**PREVOST**

## SAFETY RECALL

**SR13-01**

DATE : JANUARY 2013	SECTION : 10-FRONT AXLE
SUBJECT :	RADIUS ROD SUPPORT

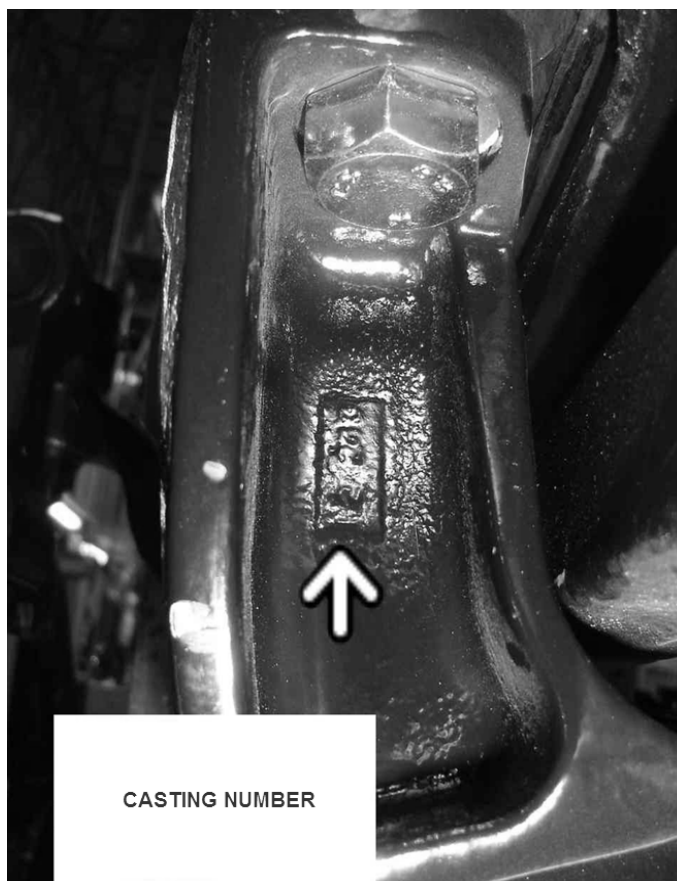
1. On front I-Beam axle, left hand side (road side). Check casting number in cavity of radius rod support 110739.

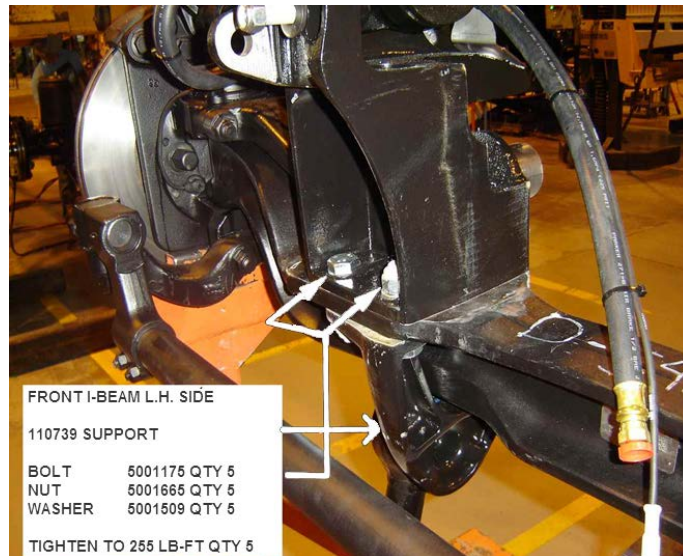
2. If casting number in cavity is **11048**, part must be replaced.

3. Dismount support and radius rod.
4. Discard hardware
5. Install replacement part with new bolts, nuts and washers.
6. Threads and holes must be clean and dry.
7. Tighten to specified torque.
8. Apply tectyl compound 680064 on bolt and nut after tightening
